**STATE OF DELAWARE  
EXECUTIVE DEPARTMENT  
OFFICE OF STATE PLANNING COORDINATION**

RE: PLUS review 2016-01-01; Concord Plaza

Thank you for meeting with State agency planners on January 27, 2016 to discuss the proposed plans for the Concord Plaza project. According to the information received, you are seeking review of a site plan for 341 residential units and 98,186 square feet of new commercial space on 41.85 acres along Silverside Road in New Castle County.

Figure 1: NRCS soil survey mapping update in the immediate vicinity of the proposed construction

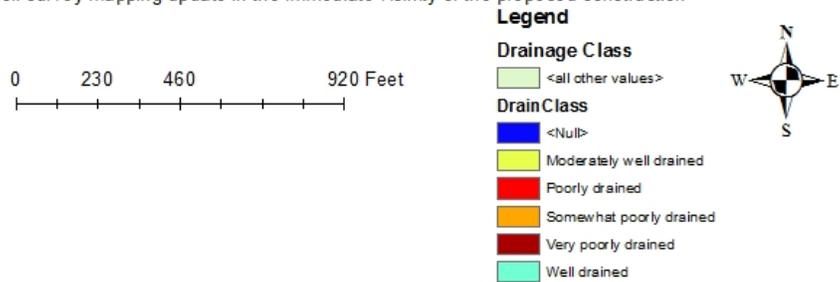
- The soil mapping units mapped in the immediate vicinity of the proposed construction are Urban land Wheaton complex (VwB), Talleyville-Montalto-Urban land complex (TdB), and Watchung (WaA). Urban land is a soil mapping unit that consists of areas that have been modified or disturbed (e.g., excavation, filling, and/or grading) so that they may no longer have specific definable properties (e.g., drainage class, permeability, soil textures, etc.), thus they often cannot be classified properly. Talleyville-Montalto-Urban land complex, however, is an exception and is classified as well-drained. Watchung is a

poorly-drained wetland associated (hydic) soil that has severe limitations for development and should be avoided.
